Sub: Revised Compendium of Axle Counter TANs – STS/E/TAN/7010 Ver. 2.0 regarding guidelines and precautions for installation of Digital Axle Counters.

Technical Advisory Note- Compendium of Axle counter TANs			
Subject	Guidelines and precautions of installation of Digital Axle Counter		
Document Number	STS/E/TAN/7010	Version	2.0
Dated	06.06.2026	Pages	Page 1 of 9

S.N.	Date of amendment	No. of Page	Version	Reasons for amendment
1.	20.11.2024	08 pages	1.0	First Issue
2.	04.06.2026	09 Pages	2.0	<p>Following Clauses are modified /removed/updated</p> <p>(i) A-Indoor Installations A-5-Typographical error is corrected.</p> <p>(ii) B-Outdoor Installation B-6, B-7 & B-9 are modified.</p> <p>(iii) C-wiring and cabling Practices C-10, C-11, C-14, C-15, C-19, C-22, C24 are modified.</p> <p>(iv) D-Power Supply Installations D-26, D-30 are modified.</p> <p>(v) E-Earthing and Surge Protection Devices E-31, E-34, E-37, E-38 E-40, E-41 E-42, E-43, E-44 are modified.</p> <p>(vi) F-Precautions during maintenance of DACs F-47, F-49, F-54 is added.</p> <p>(vii) G-Dual Detection using DACs and HASSDACs G-55, G-56, G-59- (Typographical error), G-63, G-65 are modified.</p> <p>(viii) H-Communication H-68

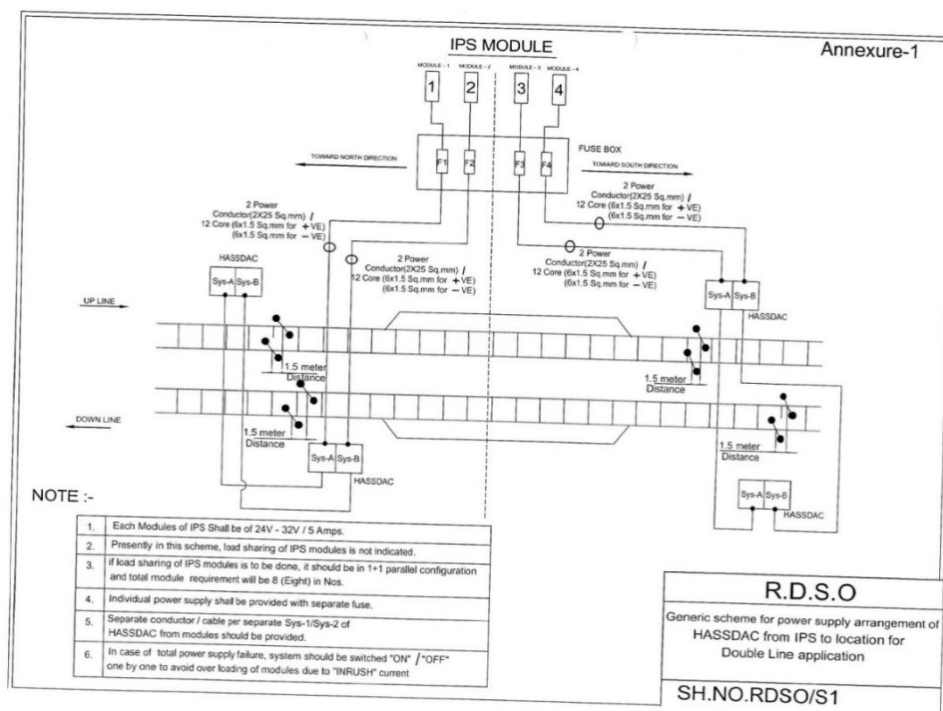
44. For surge protection arrangement in HASSDAC a generic scheme is shown below:

The SPDs as indicated above shall have properties mentioned in point 41 above.

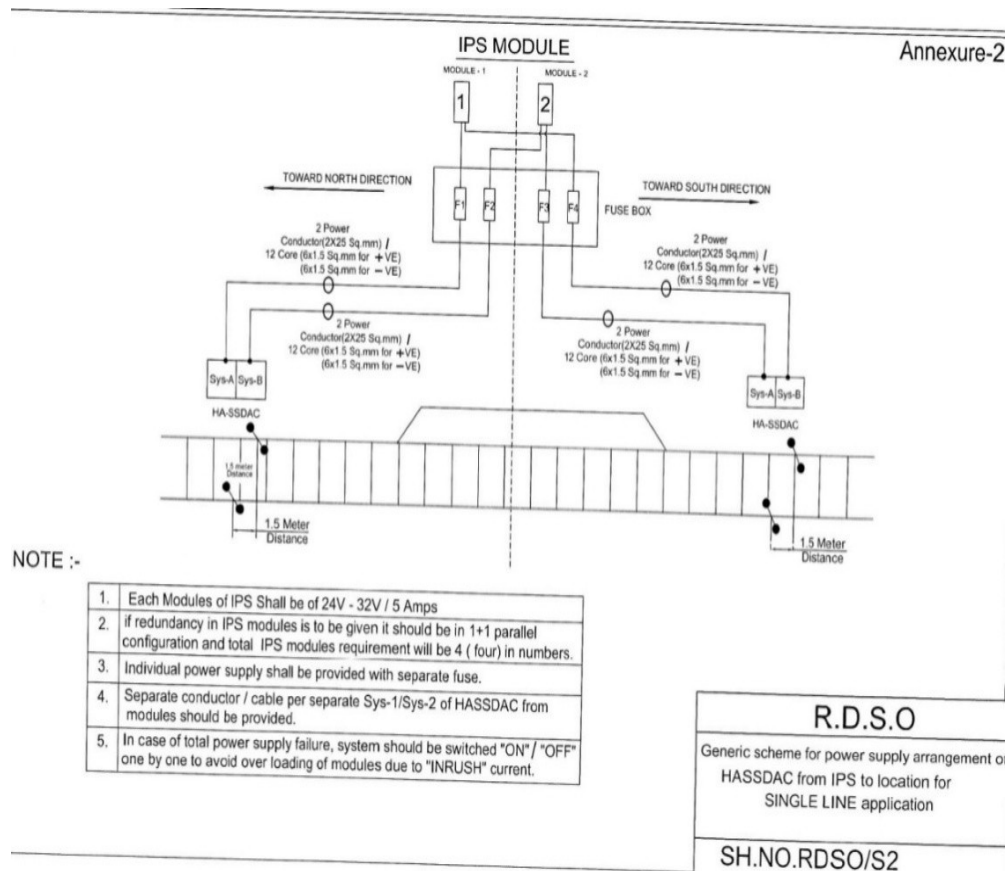
46. Generic scheme for power supply arrangement-
(i) Use of HASSDAC for double line application –
